U.S. NUCLEAR REGULATORY COMMISSION

Report No. 50-461/OL 86-02

Facility Name: Clinton Nuclear Power Station

Senior Operator Examination Comments and Resolutions

6.10 SBLC System A is in a normal STANDBY lineup with one systematic deviation - the TEST TANK OUTLET VALVE (F031) is OPEN.

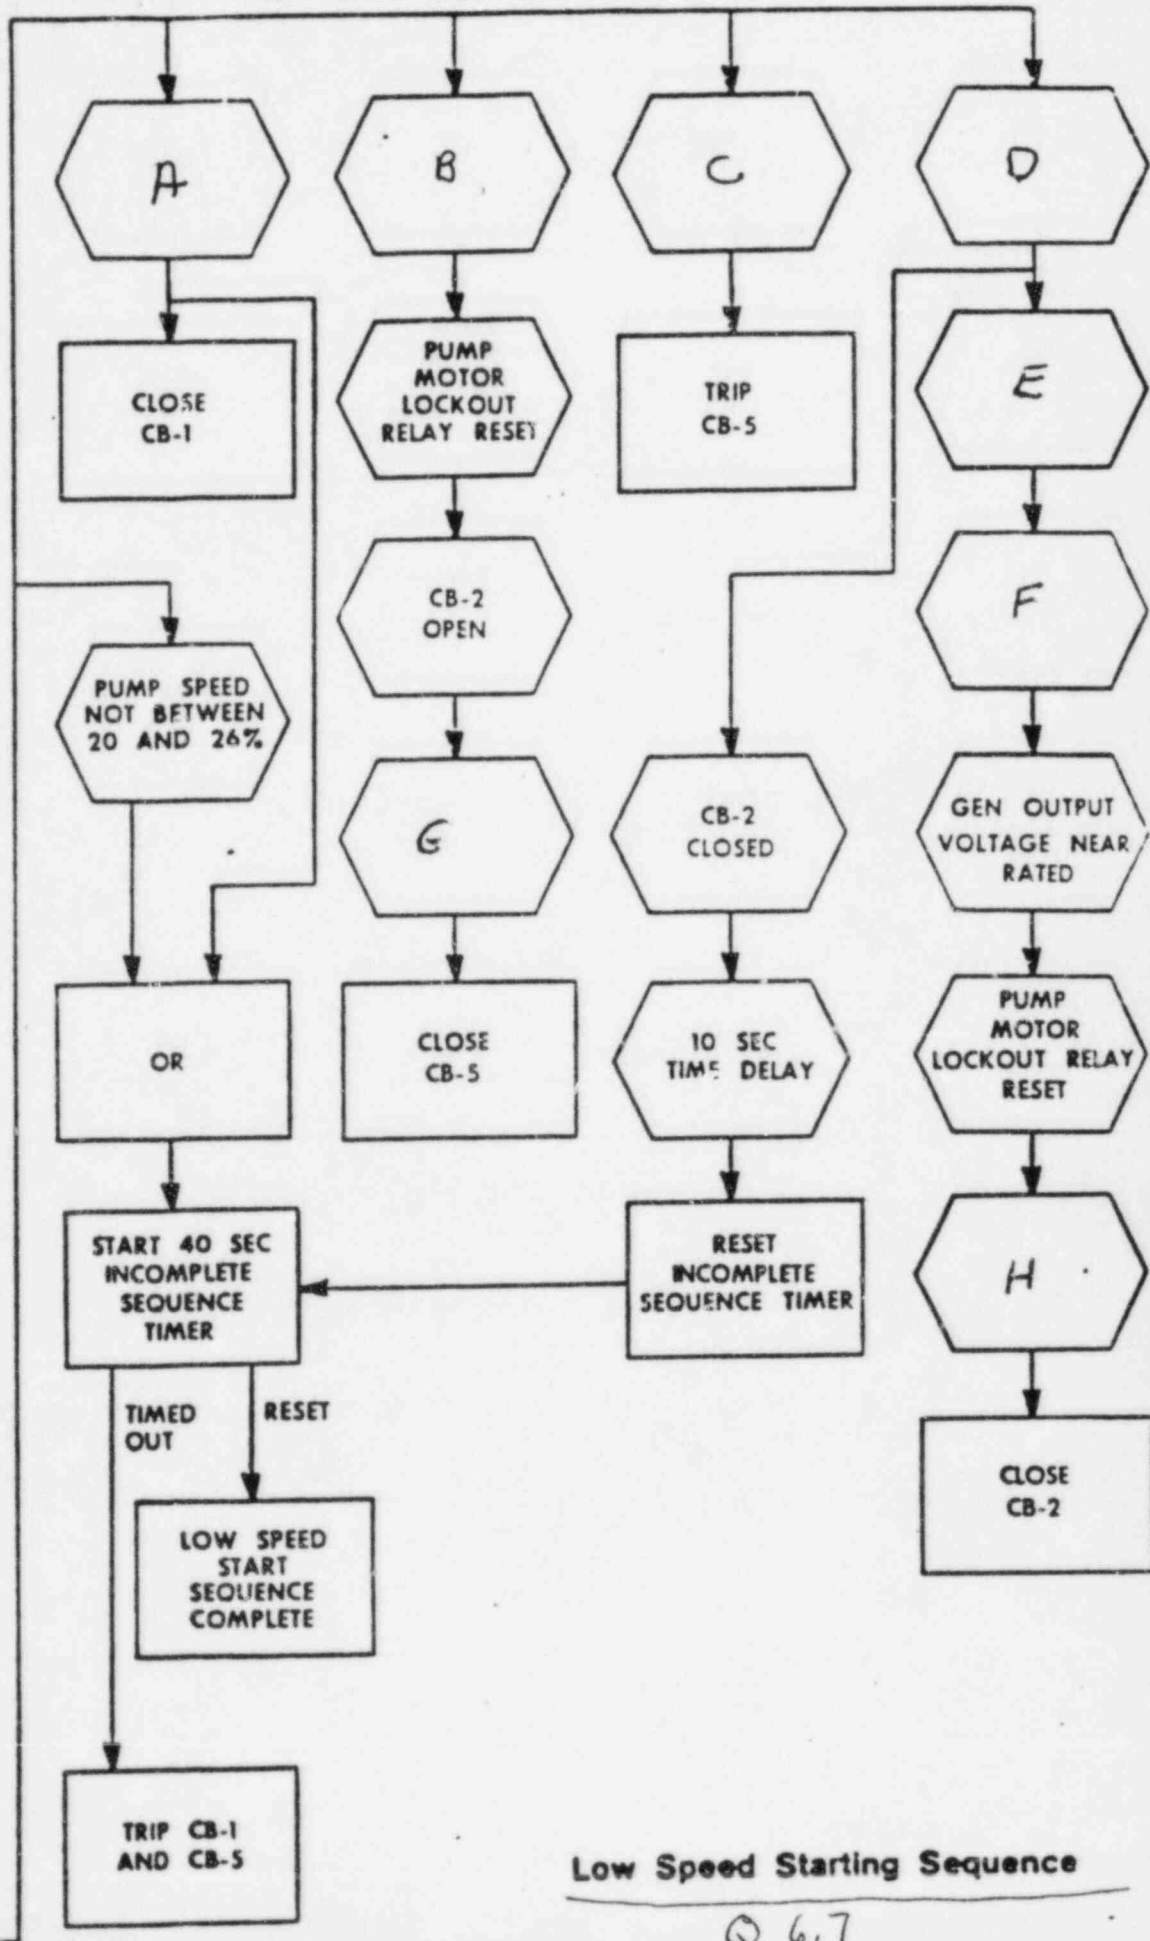
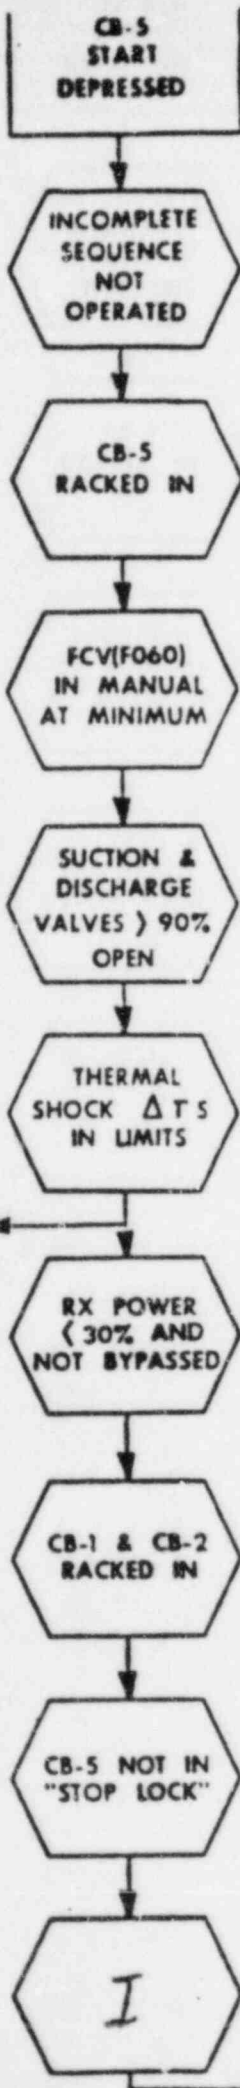
Facility Comment: The key is incorrect. Procedure 3314.01 Revision 3 page 5 of 12, a note states, "An SLC pump will not start until its associated suction valve has cycled to the full open position. The suction valve will not automatically open unless the Test Tank Suction Valve is fully closed. . . therefore, the correct response should be D. F001 does not open SBLC pump A does not start (Reference 3314.01 Revision 3 page 5 of 12).

Resolution: Comment accepted. Answer key changed.

6.10 *X D change for facility comment*
